**A** REVISION A: CARBON MONOXIDE, HEAT AND SMOKE DETECTORS ADDED AS PER BUILDING CONTROL LETTER DATED 26 JULY 2011. 15 AUGUST 2011

**B** REVISION B: WINDOWS TO DINING AREA AMENDED. WOOD BURNING STOVE OMITTED. 01 NOVEMBER 2011

PROPOSED GROUND FLOOR PLAN 1:50

PROPOSED REAR ELEVATION: SOUTH 1:50

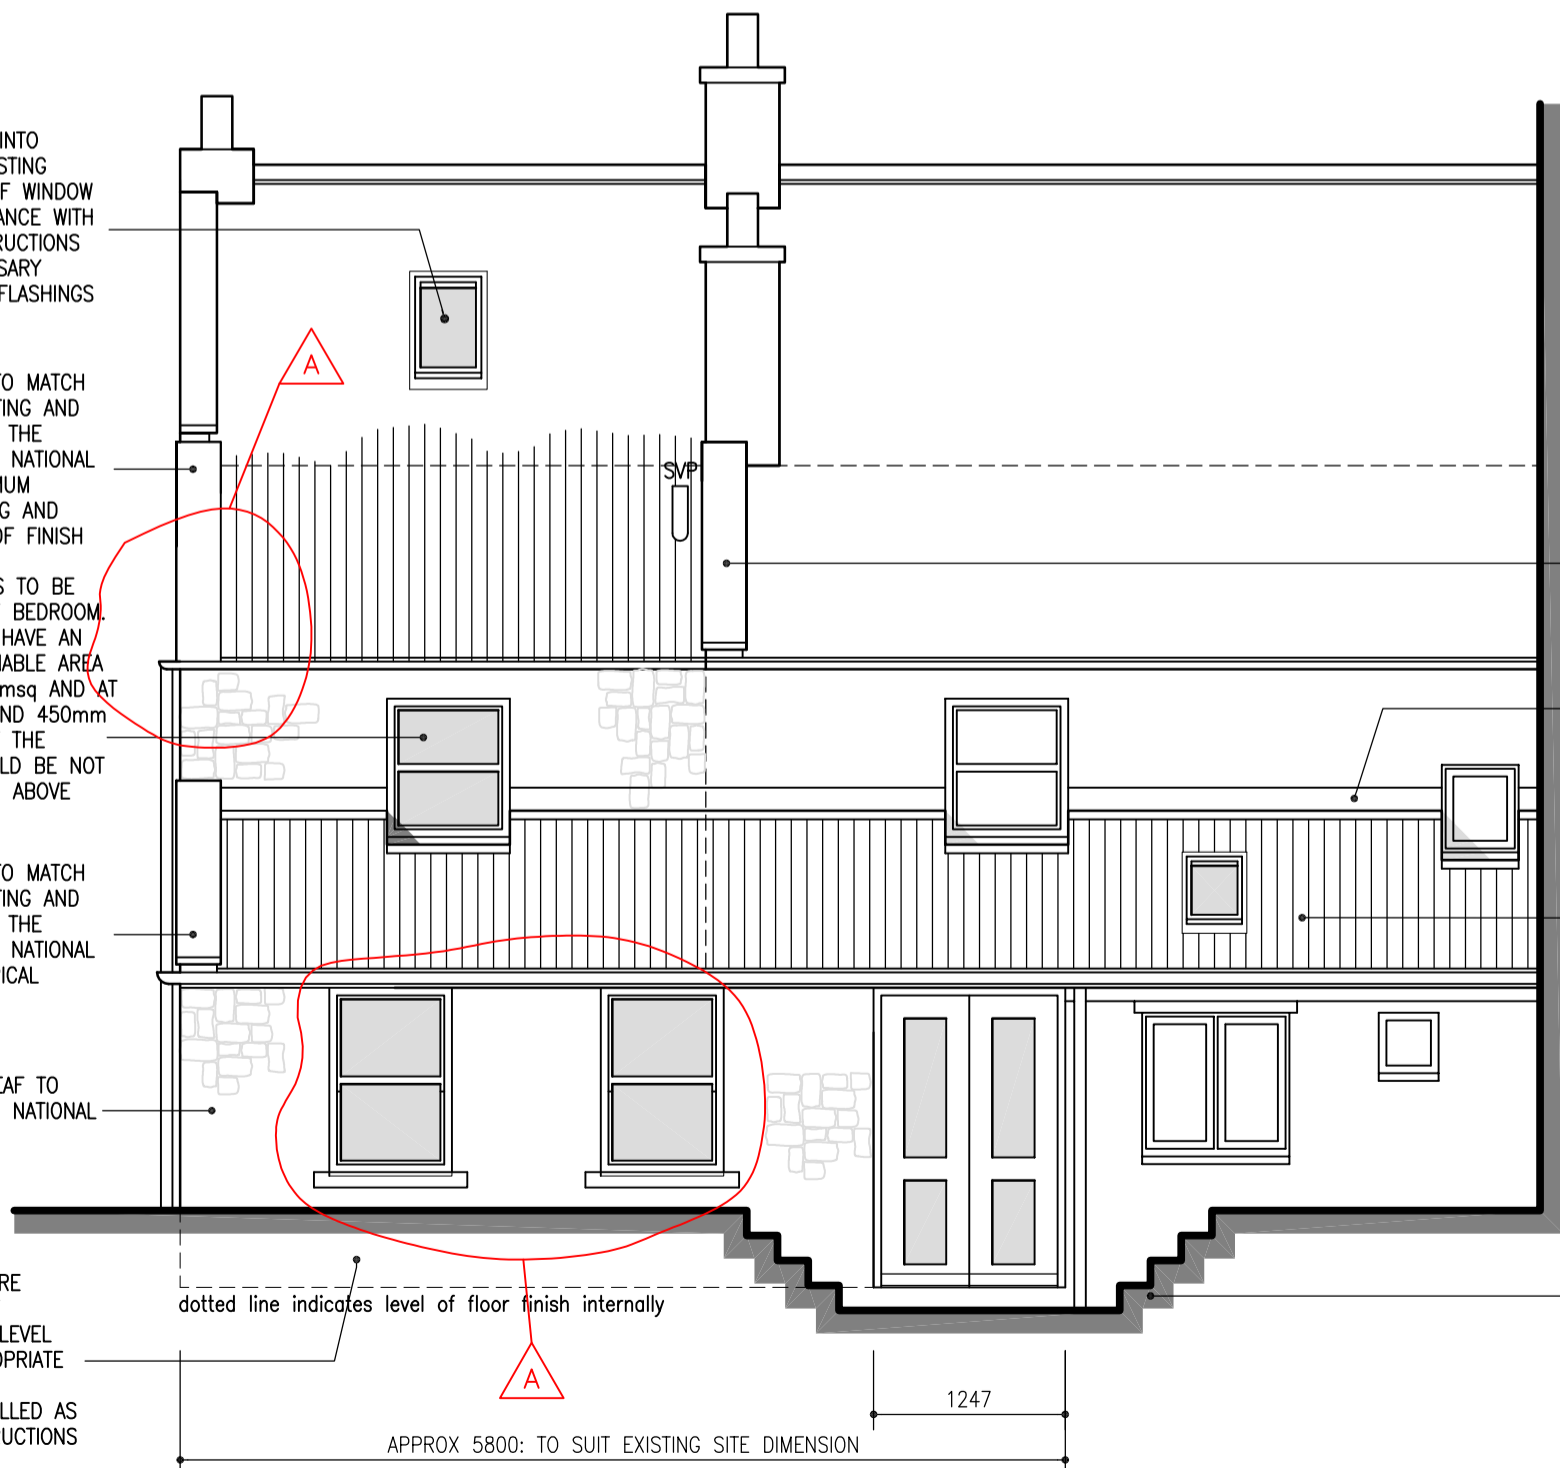
REVISION A: WINDOWS TO NEW DINING AREA AMENDED. CHIMNEY FROM WOOD BURNING STOVE  
OMITTED. 01 NOVEMBER 2011
